Planning Commission Meeting
Tuesday, October 28, 2025 @ 5:30 PM

PROJECT:	Major Subdivision Sketch Application, 3800 West US Hwy 160, 80 South Pagosa Blvd, and 100 S Pagosa Blvd
ACTION:	Planning Commission Action

STAFF REPORT: Pagosa West, Major Subdivision, Sketch Plan Review, 3800 W. US Hwy 160, 80 S. Pagosa Blvd, and 100 S. Pagosa Blvd

Figure 3

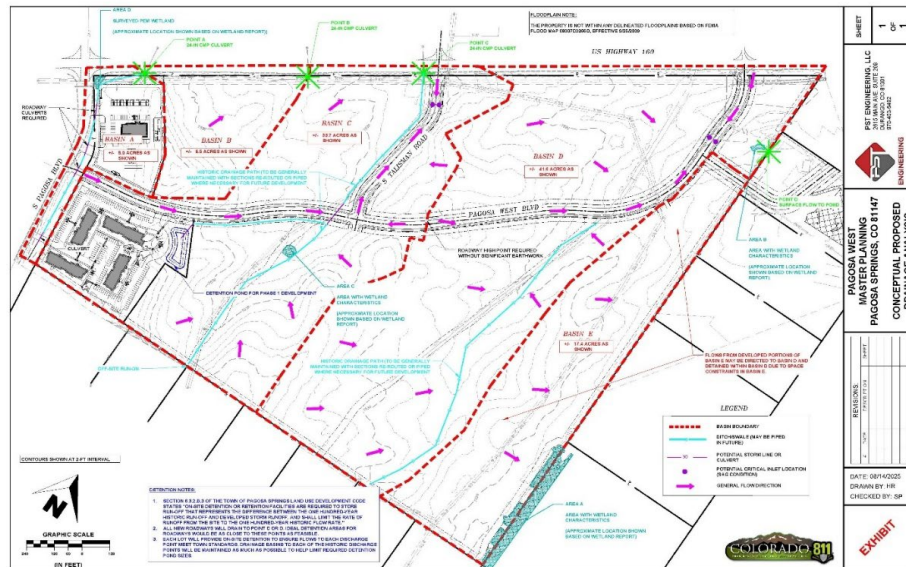
The applicant submitted a conceptual drainage plan with their application, which includes on-site detention for the developments within Phase 1. The developer also identified historic drainage basins with the intent of preservation through maintenance following the natural topography of the land (Figure 3 Below). For the submission of the Preliminary Plan Review, a drainage study, prepared by a Licensed Professional Colorado Engineer will be required. Stormwater detention is required to be depicted at Preliminary Application for all roads, sidewalks and trails.

PUBLIC STREET CROSS SECTION

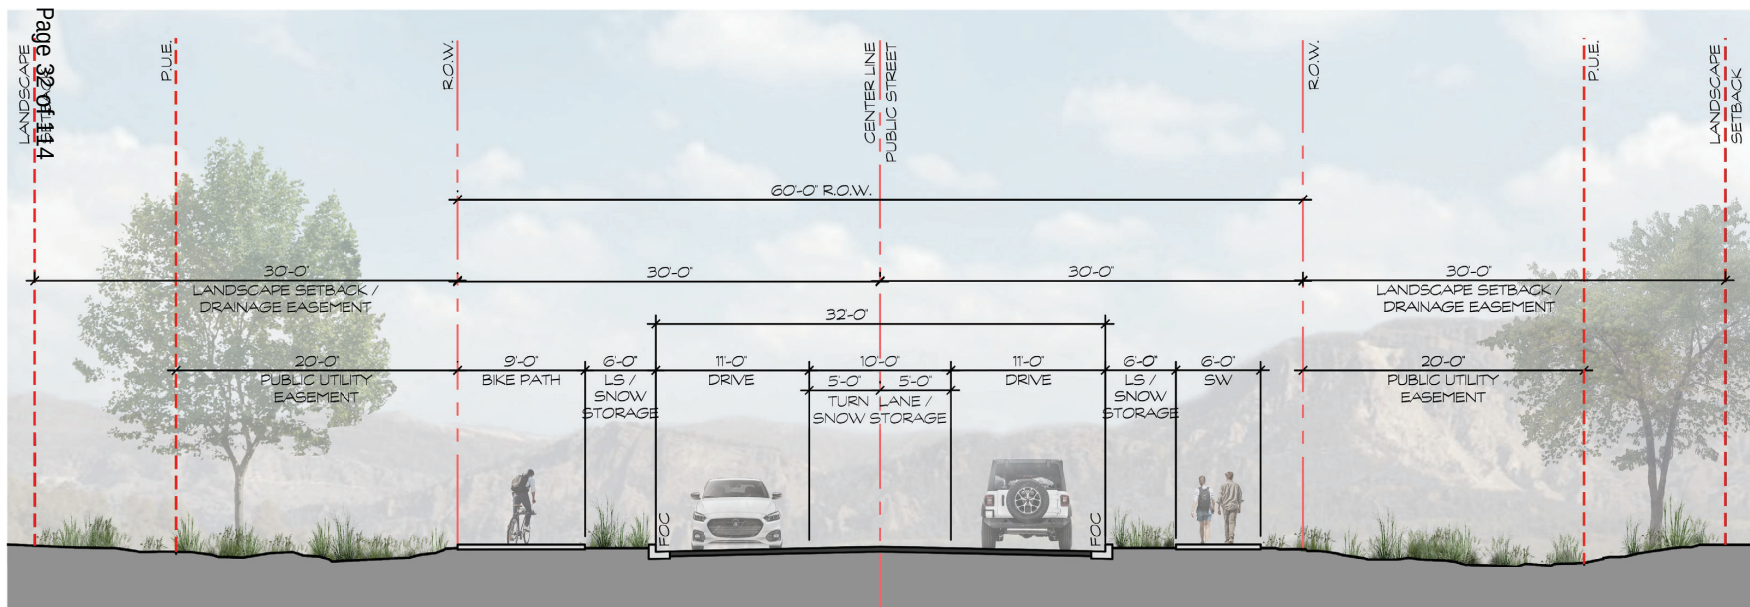
Lighting	Plan/Dark Sky		
Sight Distance	115-200 ft	115-200 ft for local	Not provided – Public works to check
Lane Width (Local Streets)	10-12 ft	Check if lanes are wide enough for 2-way traffic and emergency vehicles	11 ft proposed - meets
Crosswalks / Pedestrian Crossings	Clearly marked; ADA ramps with detectable warnings		No clearly marked ADA or crosswalks – provide at final
ROW Width	50-60 ft for local		Meets – enough rooms for lanes, sidewalks buffers – we might want more for snow storage?
Street grade	≤ 8–10% (local/collector)		Sketch stage note: must ensure slopes stay under 8–10% at preliminary/final design
